## AGENDA

### PLANNING & ZONING COMMISSION REGULAR MEETING TUESDAY, FEBRUARY 6, 2024 - 3:30 PM MCALLEN CITY HALL, 1300 HOUSTON AVENUE CITY COMMISSION CHAMBERS, 3<sup>RD</sup> FLOOR

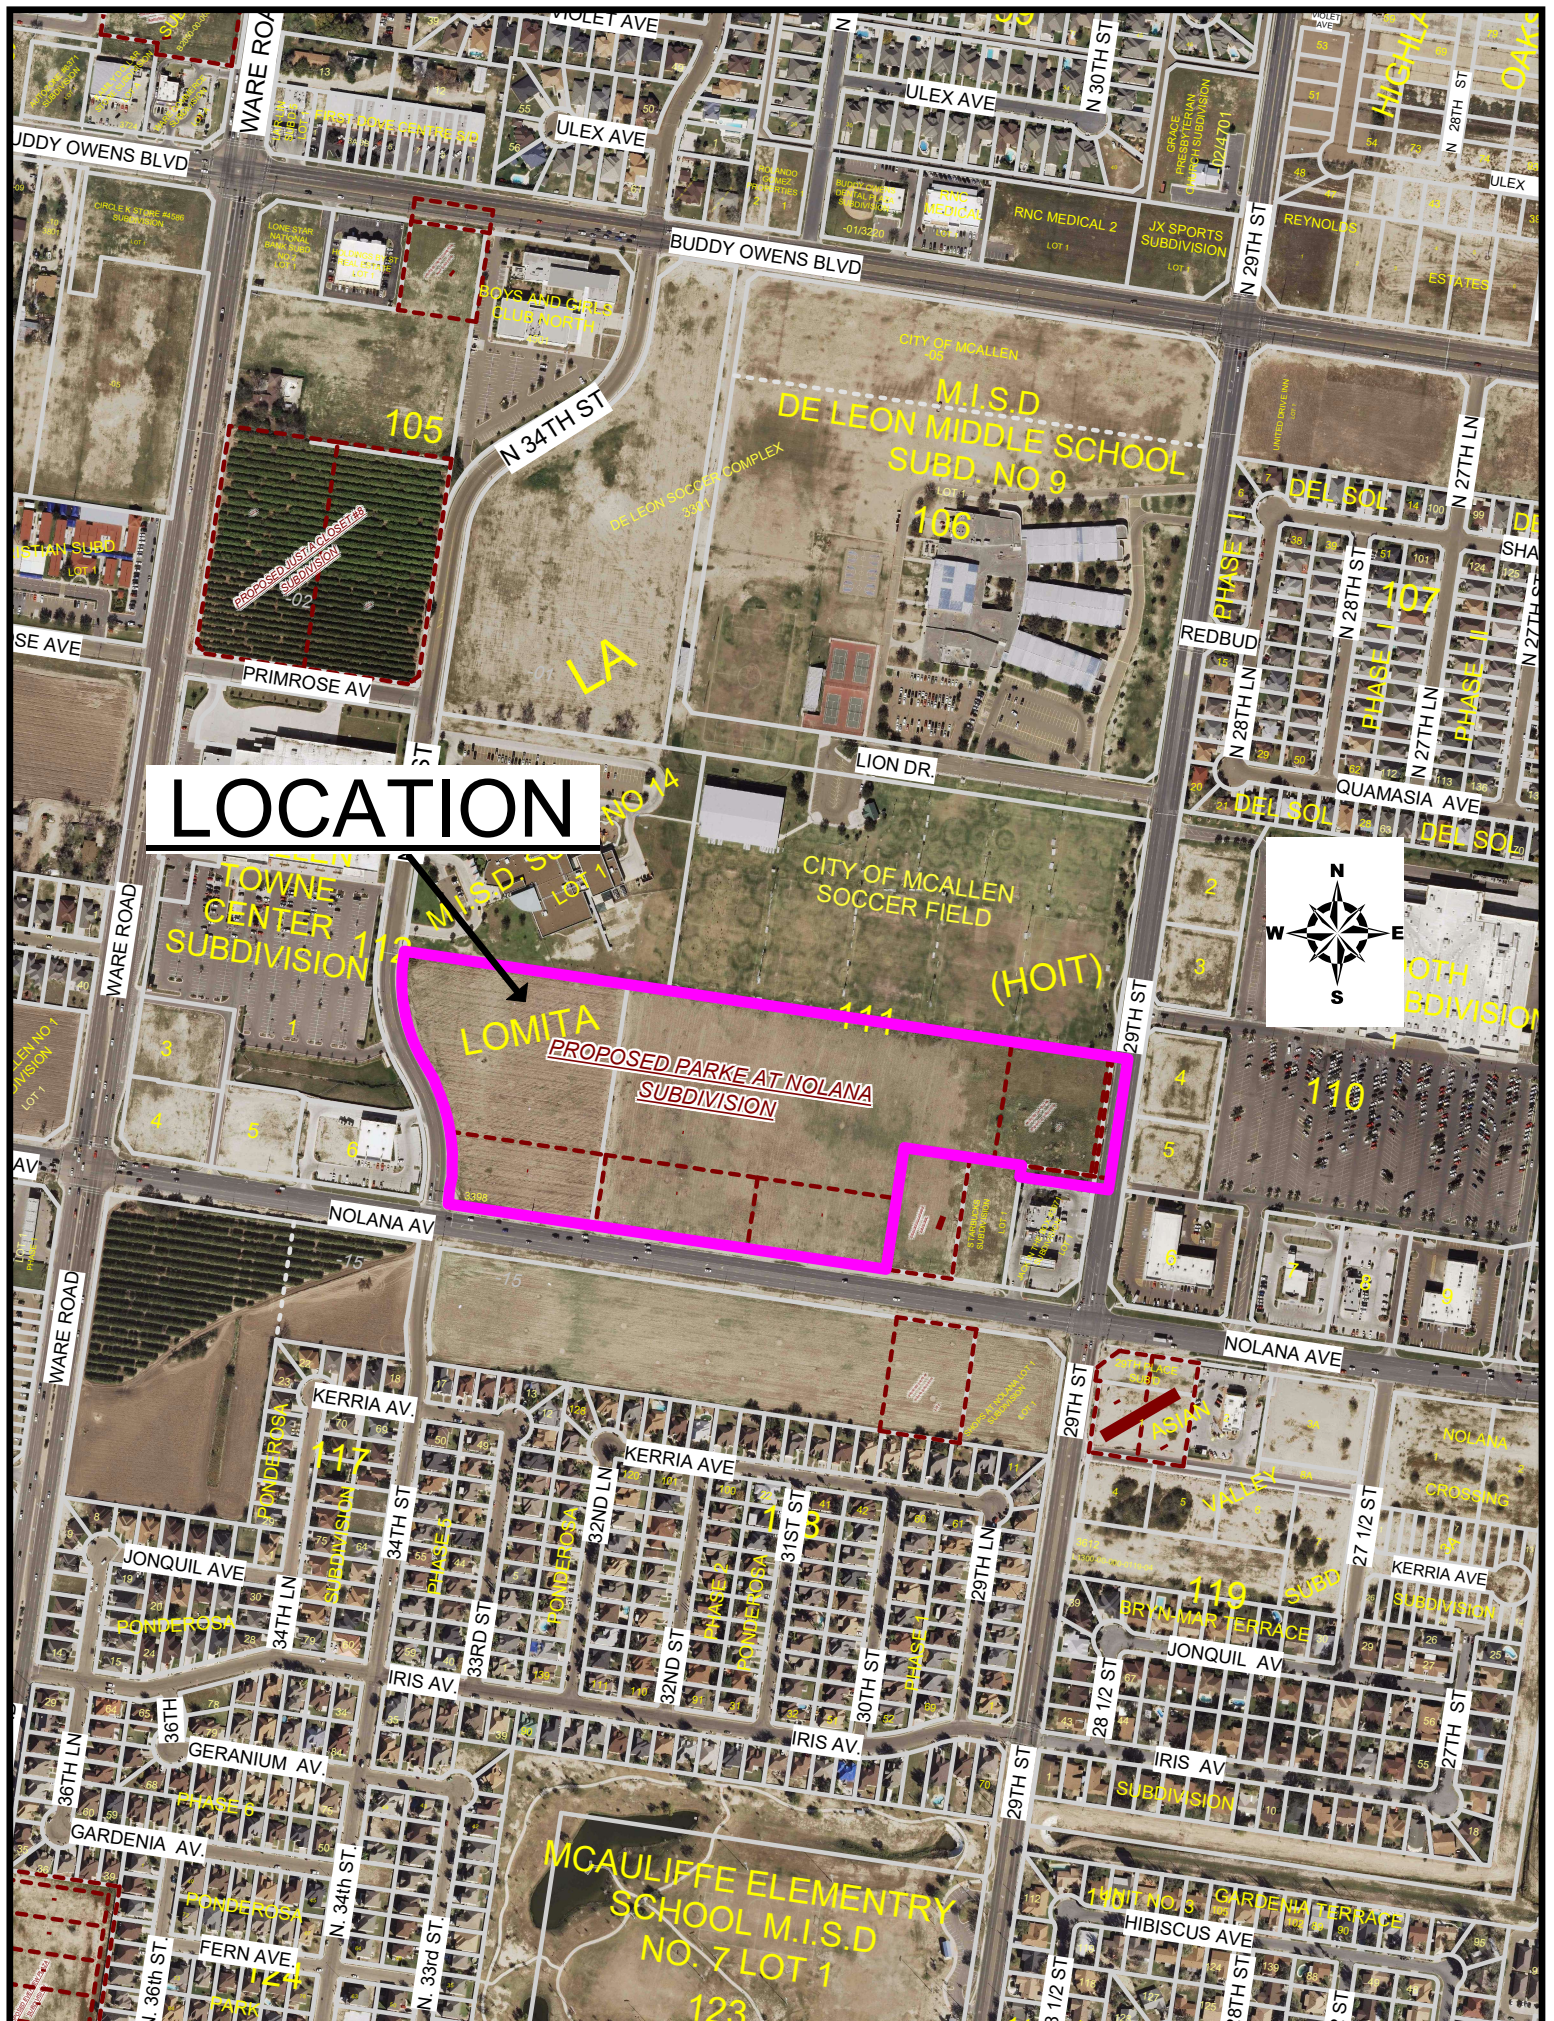
- Subdivision layout does not comply with block length requirement, please revise accordingly prior to final. If no changes please submit variance request for 1200 ft. maximum block length requirement.

| ROW: 20 ft. Paving: 16 ft.<br>*Alley/service drive easement required for commercial properties and multi-family properties.<br>Revisions Needed:<br>- Revise the intersection of common access easements to include 25 ft. x 25 ft. corner clip prior to final/recording.<br>- Ensure that access points regarding any access/service drive easements are in compliance with Traffic & Fire Department requirements, finalize prior to final/recording.<br>- Ensure all existing dedications for surrounding plats are included, prior to final. Ex. Go Carwash, Starbucks, etc. finalize prior to final/recording.<br>**Subdivision Ordinance: Section 134-106 | Required |
| Rear: In accordance with the Zoning Ordinance or greater for easements or approved site plan, whichever is greater applies.<br>Revisions Needed:<br>- Revise wording for note as noted above, prior to final/recording.<br>**5 ft. minimum setback is required from any proposed service drives.<br>**Zoning Ordinance: Section 138-356   | Required |
| * Sides: In accordance with the Zoning Ordinance or greater for easements or approved site plan, whichever is greater applies.<br>Revisions Needed:<br>- Revise wording for note as noted above, prior to final.<br>**Zoning Ordinance: Section 138-356   | Required |

| <ul style="list-style-type: none"> <li>* No curb cut, access, or lot frontage permitted along Nolana Ave. for Lots 3,4, 5, and 6, except for the common access easement between lots 3 and 4.</li> <li>- Plat note must comply with Traffic Department requirements and must be finalized prior to recording.</li> <li>**Must comply with City Access Management Policy</li> <li>* Site plan must be approved by the Planning and Development Departments prior to building permit issuance.</li> <li>* Common Areas, any private streets/drives, etc. must be maintained by the lot owners and not the City of McAllen.</li> <li>- Clarify if there are any gates proposed OR Revise plat note #12 as shown above prior to final.</li> <li>- Proposing: Common Areas, any private streets/drives, gate areas, etc. must be maintained by the lot owners and not the City of McAllen.</li> <li>* Common Areas for commercial developments provide for common parking, access, setbacks, landscaping, etc.</li> <li>* Developer/Homeowner's Association/Owner, their successors and assignees, and not the City of McAllen shall be responsible for compliance of installation and maintenance and other requirements per Section 134-168 of the Subdivision Ordinance, including but not limited to common areas and its private streets.</li> <li>**Section 110-72 applies if private subdivision is proposed.</li> <li>**Landscaping Ordinance: Section 110-72</li> <li>**Subdivision Ordinance: Section 134-168</li> <li>* Homeowner's Association Covenants must be recorded and submitted with document number on the plat, prior to recording.</li> <li>**Section 110-72 applies if private subdivision is proposed.</li> <li>**Landscaping Ordinance: Section 110-72</li> <li>**Subdivision Ordinance: Section 134-168</li> </ul> | Required |

| <p>Comments/Revisions needed:</p> <ul style="list-style-type: none"> <li>- Based on plat note No. 13, Lot 7 is for detention. Reword plat note #13 to read "Common Lot 7" prior to final/recording.</li> <li>- Some labels are illegible as they have been hindered by other labels. Review and revise as applicable prior to final/recording.</li> <li>- All signature blocks must comply with Sec 134-61 of the subdivision ordinance prior to recording.</li> <li>* Must comply with City's Access Management Policy.</li> </ul> <p>** A variance application to the 1,200 block length requirement and N/S quarter mile collector has been submitted by the engineer on December 1, 2023, and approved administratively by staff.</p> <p>The engineer has mentioned that there is no stub out on the north side to connect; therefore, a N/S collector is not feasible. The latest submitted plat shows common access easements on the plat, including a 40 ft. N/S common access easement running between lots 1&amp;2 and Lots 3&amp;4. The property's depth will be approximately 1,859 ft. at its deepest point, after ROW dedication. None of the development departments opposed the requested variance(s). The variance request was reviewed and approved administratively by staff for the following reasons:</p> <ol style="list-style-type: none"> <li>1. 35 ft. ROW for a N/S Collector (N. 33rd St.) and 70 ft. E/W Collector (Primrose Ave.) which was dedicated by McAllen Independent School District Subdivision No.9 was abandoned by the City Commission on August 14, 2000 (Ordinance No.2000-62). Therefore, there is no other N/S Collector on the north side for connection.</li> <li>2. N. 34th Street on the west side of the subdivision has become the new N/S Collector in this area. It also aligns more to the east side, as it goes to the north.</li> </ol> | Required |
